National  
Association  
of Home  
Builders

# International Codes Suggested Amendments

State and local HBAs should consider these amendments to maintain cost-effective and affordable code provisions when discussing the adoption of the 2012 International Codes. NAHB developed these amendments based on the outcome of the 2010-2011 ICC Code Development Cycles.

Table N1105.5.2(1) [R405.5.2(1)]  
SPECIFICATIONS FOR THE STANDARD REFERENCE AND PROPOSED DESIGNS

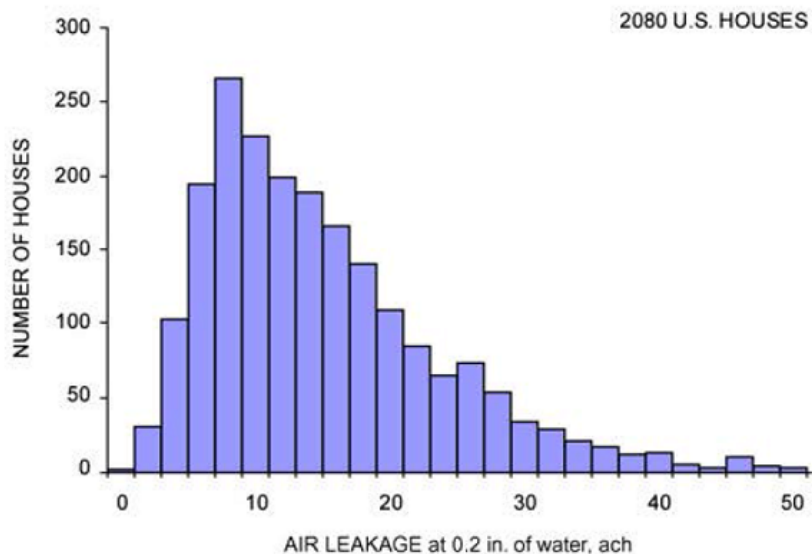
**N1102.4.1.2 (R402.4.1.2) Testing.** The building or dwelling unit shall be tested and verified as having an air leakage rate of not exceeding five air changes per hour in Climate Zones 1 ~~and 2, and three air changes per hour in Climate Zones 3~~ through 8. Testing shall be conducted in accordance with ASTM E 779 or ASTM E 1827 and reported at a pressure of 0.2 inches w.g. (50 Pascals). Where required by the *code official*, testing shall be conducted by an *approved* third party. A written report of the results of the test shall be signed by the party conducting the test and provided to the *code official*. Testing shall be performed at any time after creation of all penetrations of the *building thermal envelope*.

BUILDING COMPONENT	STANDARD REFERENCE DESIGN	PROPOSED DESIGN
Air exchange rate	<p>Air leakage rate of 5 air changes per hour in Climate Zones 1 <del>and 2, and 3 air changes per hour in Climate Zones 3</del> through 8 at a pressure of 0.2 inches w.g (50 Pa). The mechanical ventilation rate shall be in addition to the air leakage rate and the same as in the proposed design, but no greater than <math>0.01 \times CFA + 7.5 \times (Nbr + 1)</math></p> <p>where:</p> <p><i>CFA</i> = conditioned floor area</p> <p><i>Nbr</i> = number of bedrooms</p> <p>Energy recovery shall not be assumed for mechanical ventilation.</p>	<p>For residences that are not tested, the same air leakage rate as the standard reference design. For tested residences, the measured air exchange rate<sup>a</sup>.</p> <p>The mechanical ventilation rated shall be in addition to the air leakage rate and shall be as proposed.</p>

Table R405.5.2(1)  
SPECIFICATIONS FOR THE STANDARD REFERENCE AND PROPOSED DESIGNS

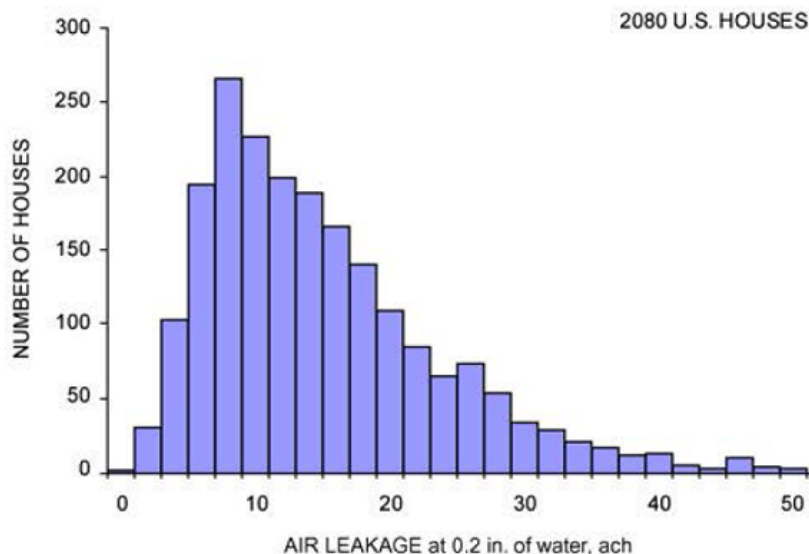
**R402.4.1.2 Testing.** The building or dwelling unit shall be tested and verified as having an air leakage rate not exceeding five air changes per hour in Climate Zones 1 ~~and 2, and three air changes per hour in Climate Zones 3~~ through 8. Testing shall be conducted in accordance with ASTM E 779 or ASTM E 1827 and reported at a pressure of 0.2 inch w.g. (50 Pascals). Where required by the *code official*, testing shall be conducted by an *approved* third party. A written report of the results of the test shall be signed by the party conducting the test and provided to the *code official*. Testing shall be performed at any time after creation of all penetrations of the *building thermal envelope*.

BUILDING COMPONENT	STANDARD REFERENCE DESIGN	PROPOSED DESIGN
Air exchange rate	<p>Air leakage rate of 5 air changes per hour in Climate Zones 1 <del>and 2, and 3 air changes per hour in Climate Zones 3</del> through 8 at a pressure of 0.2 inches w.g (50 Pa). The mechanical ventilation rate shall be in addition to the air leakage rate and the same as in the proposed design, but no greater than <math>0.01 \times CFA + 7.5 \times (Nbr + 1)</math></p> <p>where:</p> <p><i>CFA</i> = conditioned floor area</p> <p><i>Nbr</i> = number of bedrooms</p> <p>Energy recovery shall not be assumed for mechanical ventilation.</p>	<p>For residences that are not tested, the same air leakage rate as the standard reference design. For tested residences, the measured air exchange rate<sup>a</sup>.</p> <p>The mechanical ventilation rated shall be in addition to the air leakage rate and shall be as proposed.</p>
